<b>DOCKETED</b>	
<b>Docket Number:</b>	23-OPT-02
<b>Project Title:</b>	Darden Clean Energy Project
<b>TN #:</b>	260647
<b>Document Title:</b>	Supplemental Data Response Set 1 - Appendix D SUP DR AQ-7 Updated Appendix N
<b>Description:</b>	Includes a redline and clean version of the updated Appendix N Air Quality and Greenhouse Gas Emissions Study, provided in response to SUP DR AQ-7 as Appendix D of Supplemental Response Set 1. Includes updates to Appendix N-2 Air Quality and Greenhouse Gas Emissions Calculations, provided in response to SUP DR AQ-7 as Appendix D of Supplemental Response Set 1.
<b>Filer:</b>	Megan Knight
<b>Organization:</b>	Rincon Consultants, Inc.
<b>Submitter Role:</b>	Applicant Consultant
<b>Submission Date:</b>	12/13/2024 4:19:28 PM
<b>Docketed Date:</b>	12/13/2024

SUP DR AQ-7 Updated Appendix N

# Darden Clean Energy Project

## Air Quality and Greenhouse Gas Emissions Study

Figure 2 Project Site

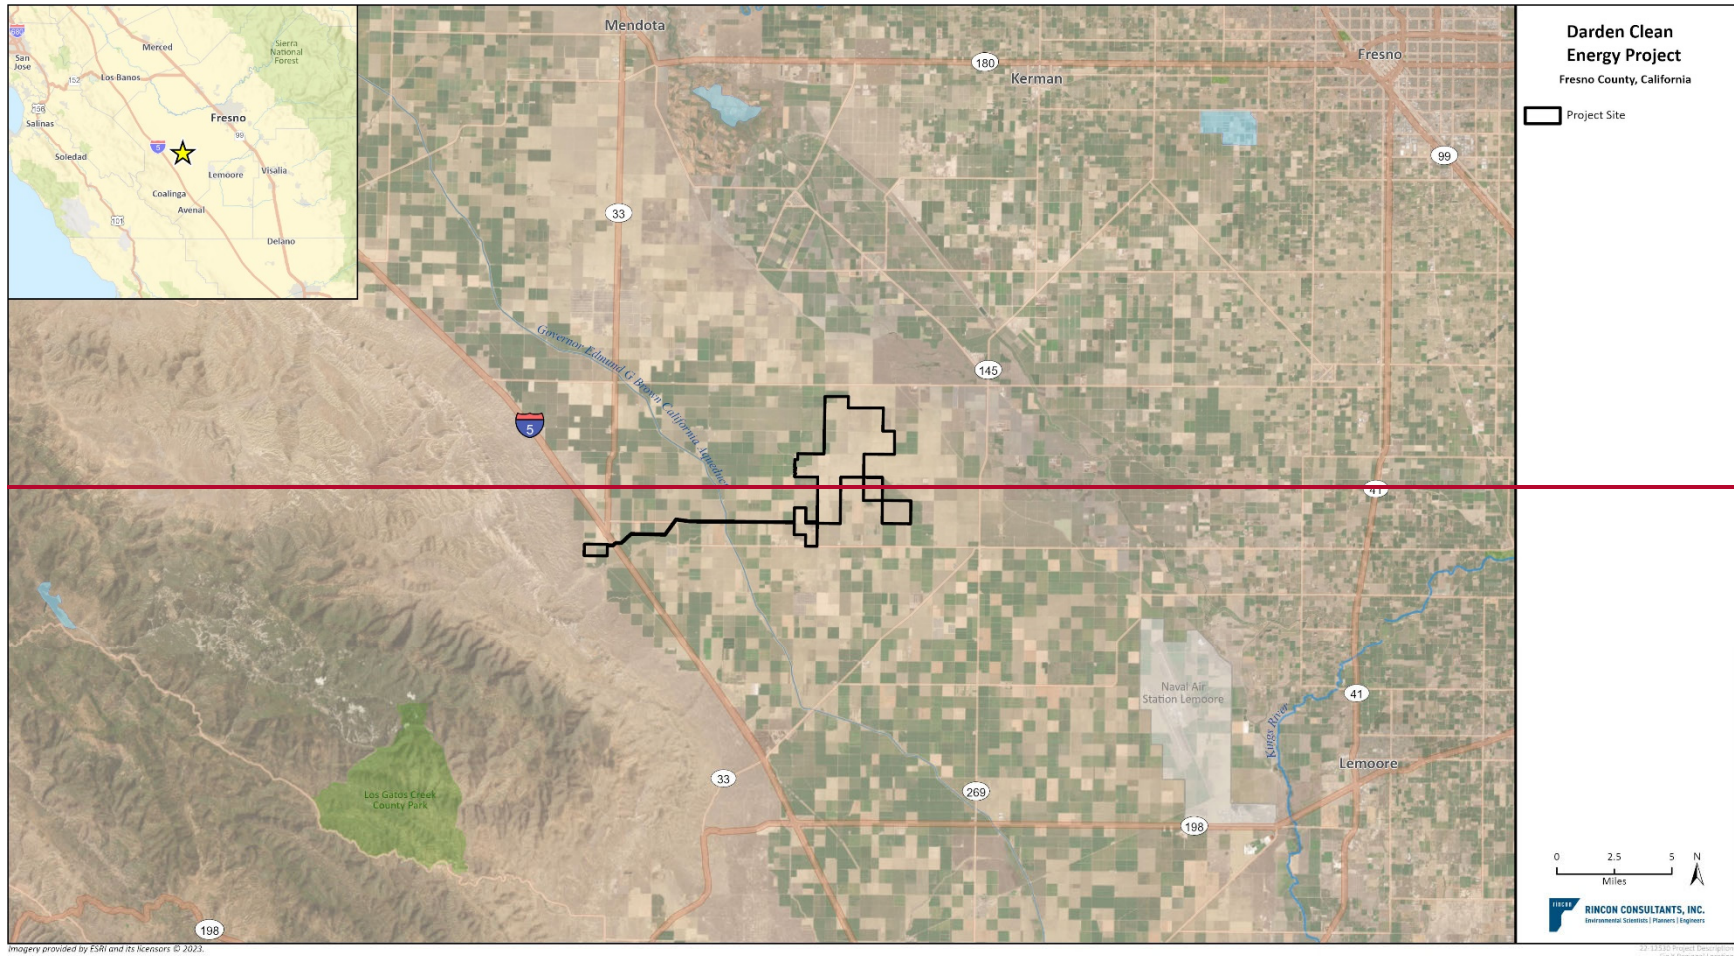
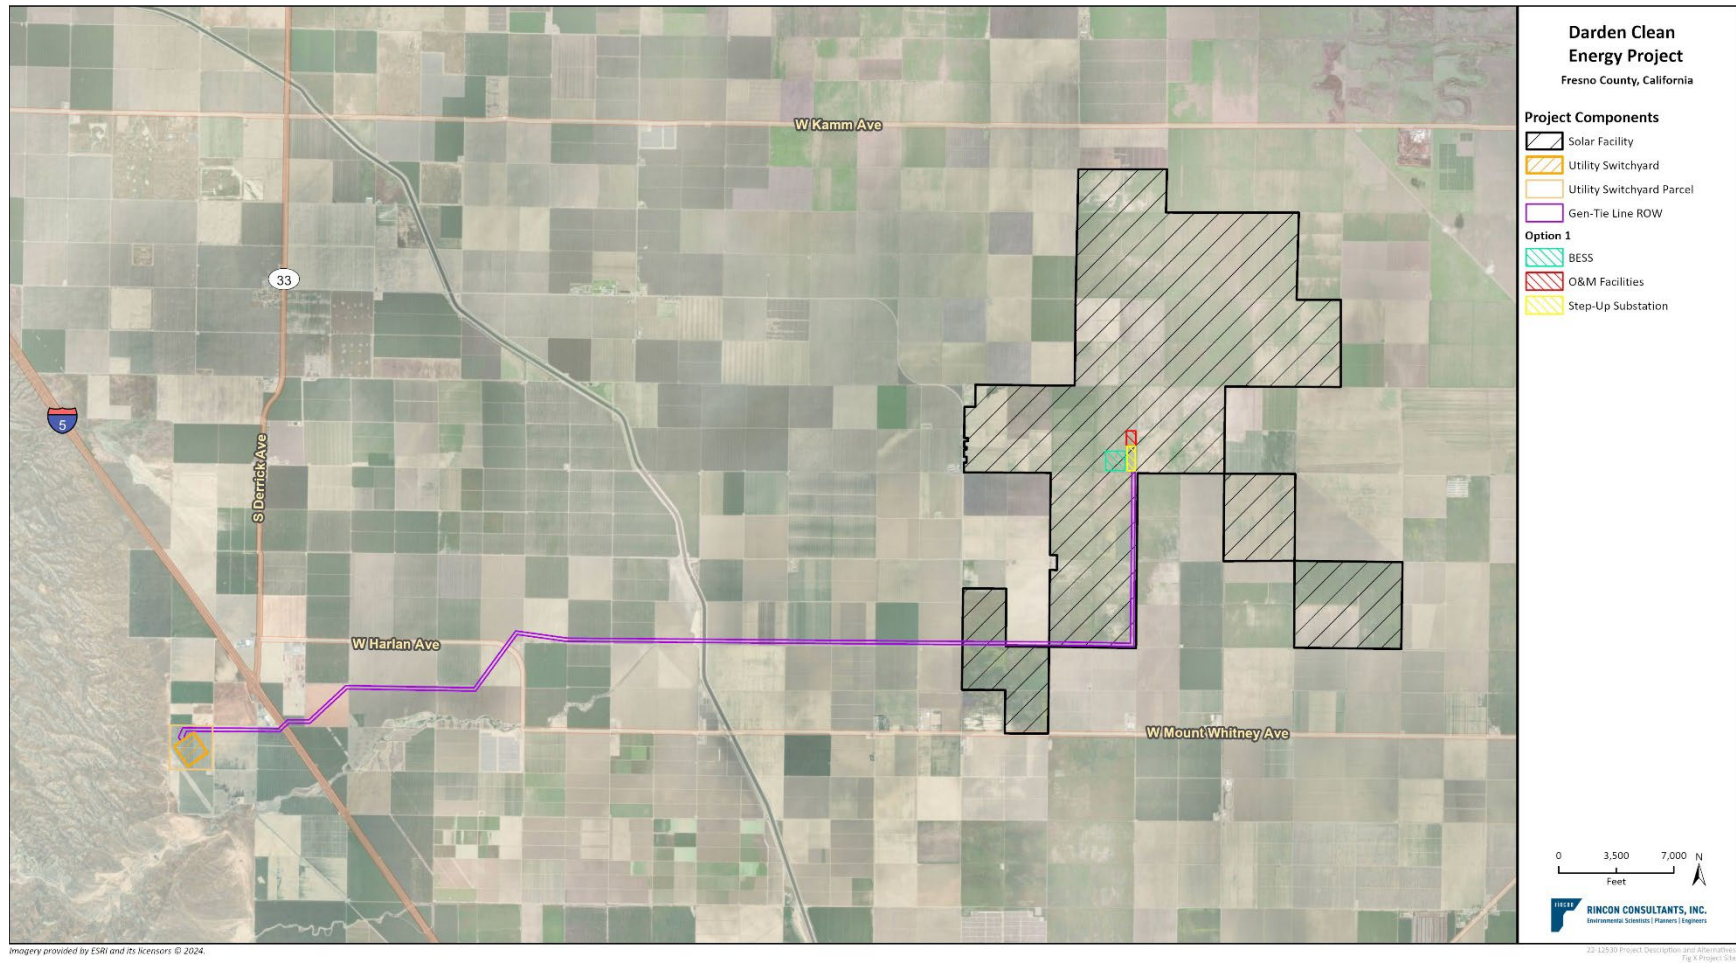
The Project site is an irregular shape, located in an agricultural area of unincorporated Fresno County south of the community of Cantua Creek (Figure 1). The proposed solar facility, ~~and Options 1 and 2-BESS, and step-up substation, and green hydrogen facility component~~ sites would be located on approximately 9,100 acres of land currently owned by Westlands Water District, between South Sonoma Avenue to the west and South Butte Avenue to the east. The proposed approximately ~~10 to~~ 15-mile gen-tie line would span west from the intersection of South Sonoma Avenue and West Harlan Avenue to immediately west of Interstate 5 (I-5), where it would connect to the proposed utility switchyard along Pacific Gas and Electric Company (PG&E)'s Los Banos-Midway #2 500-kV transmission

line (Figure 2). ~~The alternate green hydrogen facility site being considered is located adjacent to the proposed utility switchyard site.~~

One utility-owned switchyard, ~~approximately 1,000 by 1,600 feet (approximately 40-50 acres)~~ in size would serve as the facility required to electrically connect the Project generation onto the utility's 500-kV transmission network. As shown in Figure 2, the utility switchyard would be located on the west side of the Project and serve as a termination point for the Project gen-tie and will initially loop in the Los Banos-Midway #2 500-kV transmission line. The utility switchyard would contain approximately five (5) 500 kV utilize high-voltage circuit breakers and would be surrounded by a new security wall or chain link barbed wire security fence up to approximately 20-feet in height with a secure gate accessible only by PG&E staff. , switches, and series capacitor line compensation equipment in a breaker-and-a-half (BAAH) configuration and would be designed and constructed in alignment with the interconnecting utility's standards.

The Project site is an irregular shape, located in an agricultural area of unincorporated Fresno County south of the community of Cantua Creek (Figure 1). The proposed solar facility, BESS, and step-up substation sites would be located on approximately 9,100 acres of land currently owned by Westlands Water District, between South Sonoma Avenue to the west and South Butte Avenue to the east. The proposed approximately 15-mile gen-tie line would span west from the intersection of South Sonoma Avenue and West Harlan Avenue to immediately west of Interstate 5 (I-5), where it would connect to the proposed utility switchyard along Pacific Gas and Electric Company (PG&E)'s Los Banos-Midway #2 500-kV transmission line (Figure 2).

One utility-owned switchyard, approximately 50 acres in size would serve as the facility required to electrically connect the Project generation onto the utility's 500-kV transmission network. As shown in Figure 2, the utility switchyard would be located on the west side of the Project and serve as a termination point for the Project gen-tie and will initially loop in the Los Banos-Midway #2 500-kV
